Addendum No. 1

Rock River Water Reclamation District Plant Concrete Repairs 2019 - Chlorine Contact Tank & Plant Drainage Improvements Capital Project No. 1950

This Addendum Number 1, dated March 15, 2019, for the above referenced project, supersedes all contrary and conflicting information in the specifications and contract documents, which are hereby supplemented or revised as follows:

CONCRETE HEADWALL FOR PIPE UNDERDRAINS

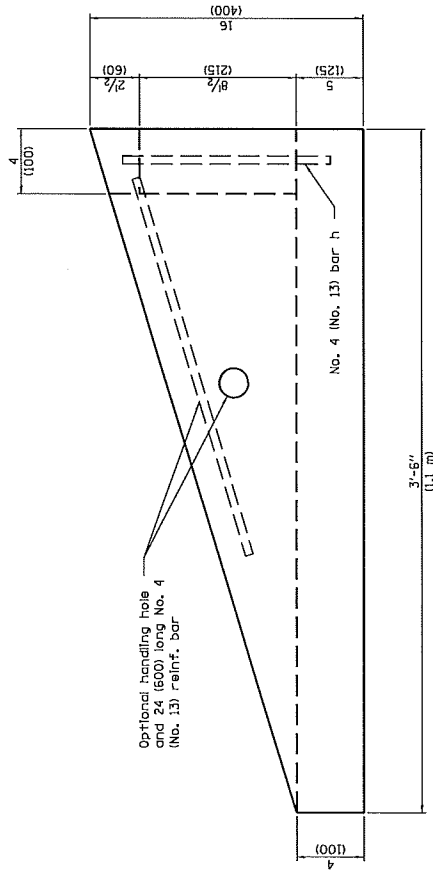
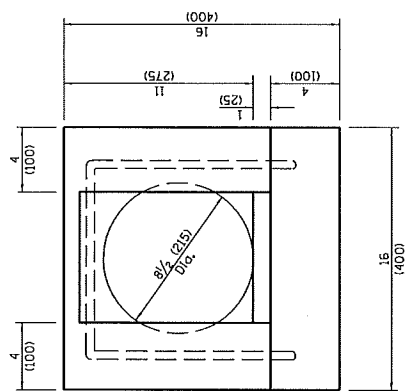
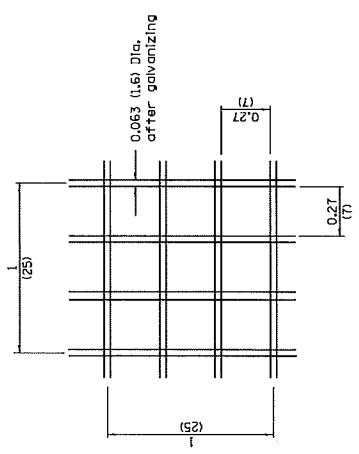
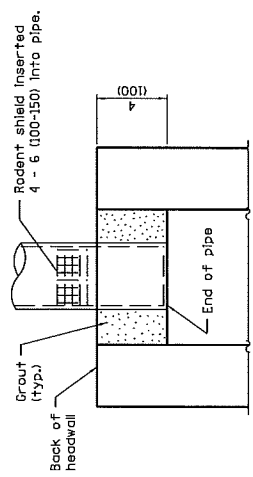
1. PART 11.1 General: REVISE Part 11.1 as follows:
The work shall include furnishing and installing a utility trench system, **including the 4-inch PVC drain pipe and concrete underdrain headwall**, as shown on the drawings.
2. PART 11.2 Materials: REVISE Part 11.2 as follows:
Replace DK020 with DK 030 and DK100 End cap
Replace Type 492Q with Type 416 Galvanized steel solid cover
3. PART 11.2 Materials: ADD as follows:
The concrete underdrain headwall shall be in accordance IDOT standards. See Section III for detail.
4. PART 11.3 Required Submittals: ADD 11.3.3 as follows:
11.3.3 Concrete Underdrain Headwall
5. PART 11.4 Payment: ADD as follows:
The cost of the drain pipe and concrete underdrain headwall shall be considered incidental to the cost of Utility Trench, Complete.

1. DATA SHEETS: REMOVE Data Sheet Type 492Q and ADD Concrete Headwall for Pipe Underdrains.
